VALUE ENGINEERING STUDY
OF
I-64 MAJOR WIDENING

ITEM NUMBERS: 5-2035.40, 5-2035.70 & 5-65.40/.41 Extension

January 12-16, 2009

VE GROUP, L.L.C.

**VALUE ENGINEERING ALTERNATIVE
I-64 BRIDGE OVER CARDWELL LANE**

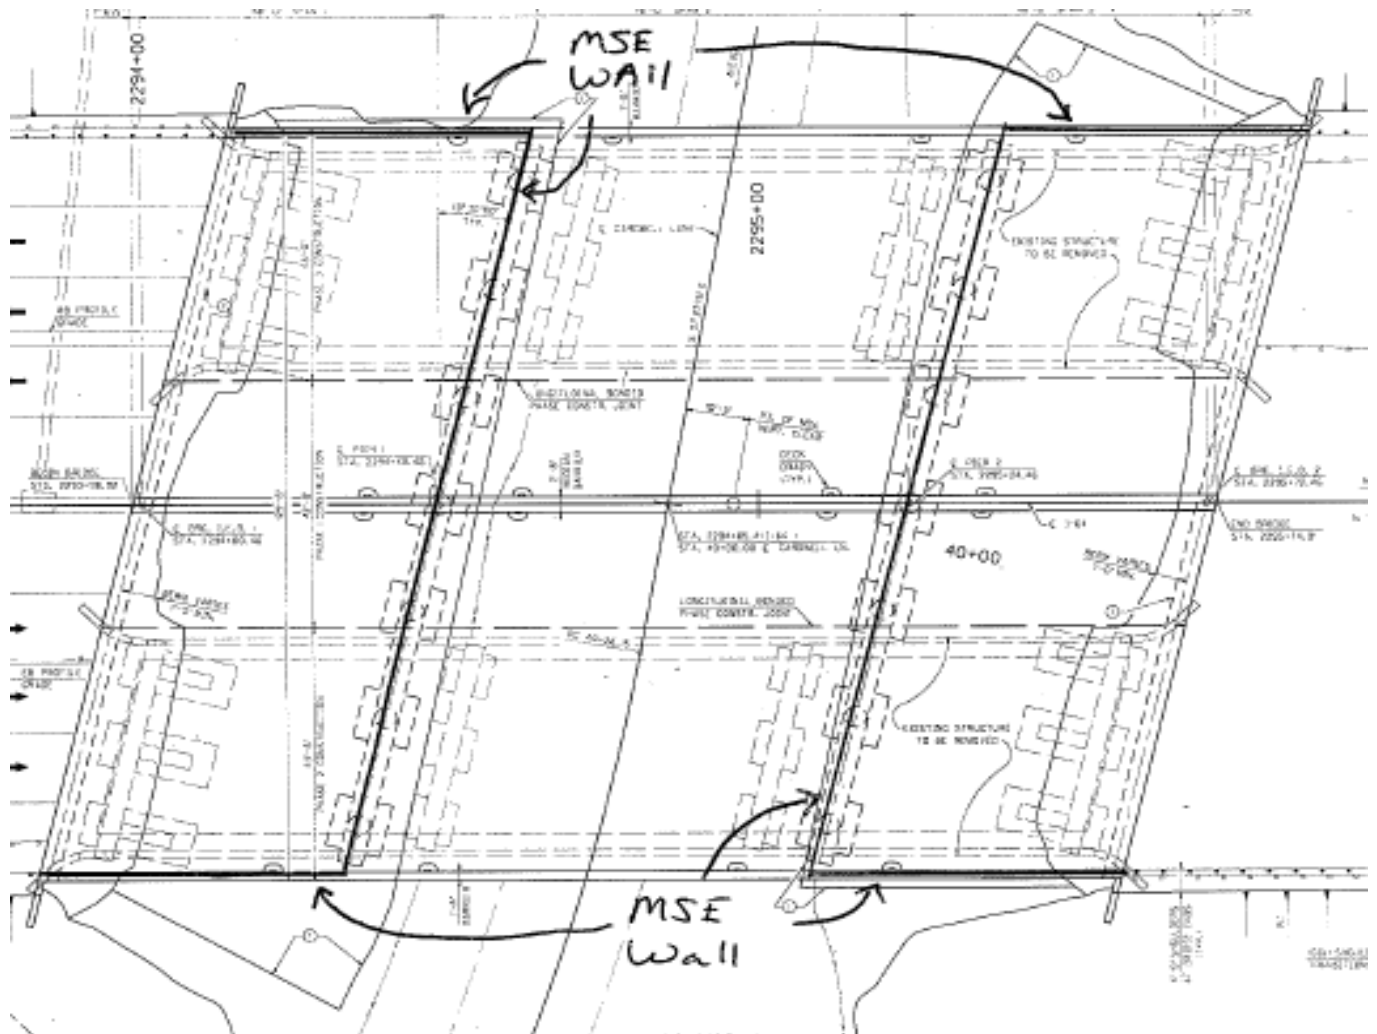
The Value Engineering Team recommends constructing a single span of 86' to bridge Cardwell Lane with MSE walls. The Value Engineering Alternative will eliminate bridge piers; decrease construction cost; and future maintenance needs.

Proposed Project Limits and associated issues for Item Numbers 05-2035.40 and 05-2035.70, Interstate 64.

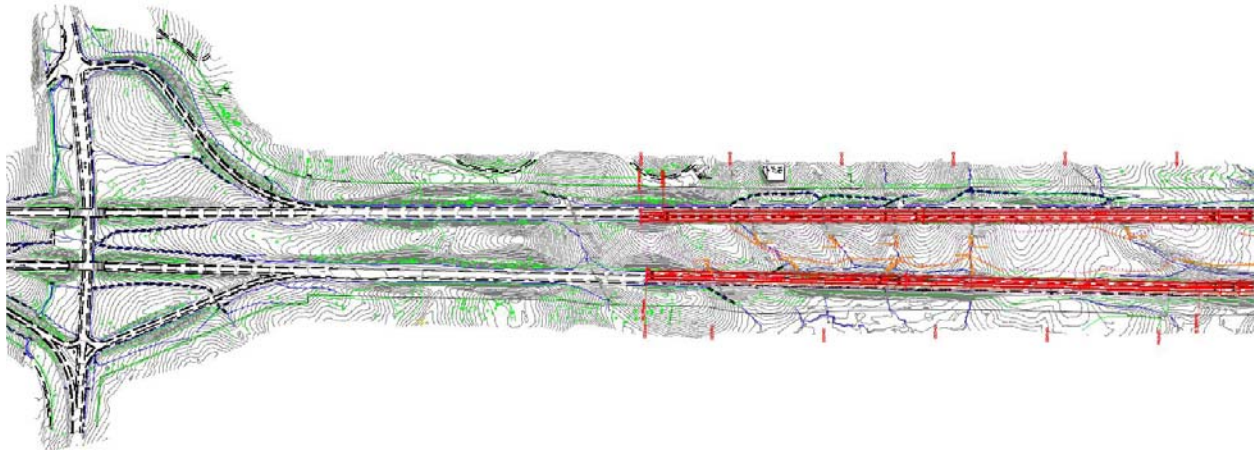
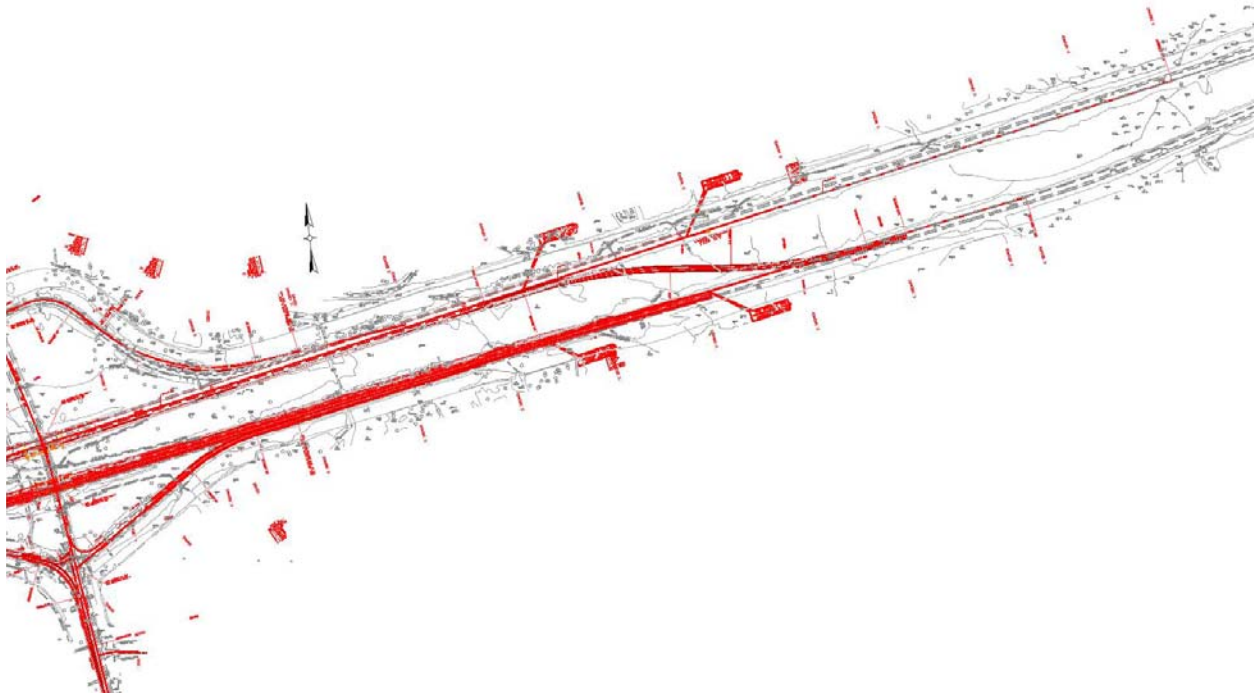
As proposed Item Number 05-2035.40 has 739,218 CY of Roadway Excavation with 136,275 CY of material to be wasted off-site. This creates the necessity of an offsite waste area and would include additional costs for hauling and disposing of excess material.

Item Number 05-2035.70 has 168,358 CY of Embankment in Place and would require a borrow totaling 10,945 CY. This makes it necessary to find an offsite borrow area and would add additional cost for hauling and placing said material.

Option “C” Ensure MOT plans match at adjoining ends.

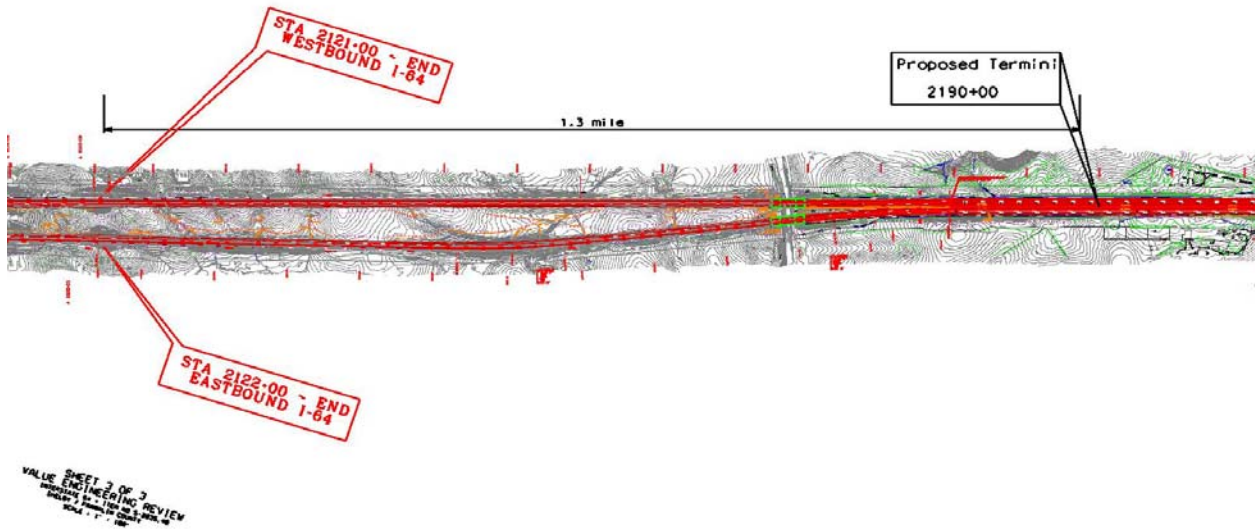
Need to provide MOT plan that would be contingent on jobs being let at separately, but ongoing during same time frame.

The west end 05-2035.70 currently has phased construction with traffic remaining in EB and WB lanes respectively. If this project was let while 05-2035.40 was ongoing then a plan would need to be drawn up to leave all traffic in WB lanes going into 05-2035.70. There is a great potential for scheduling conflict if two contractors were not on same schedule for traffic switches. This would lead to a high likelihood of change orders for delays or modifications during construction to MOT plan.

Of the 3 options this one seems to be the least desirable due to requirement that 2 projects coordinate traffic switches to a high degree.
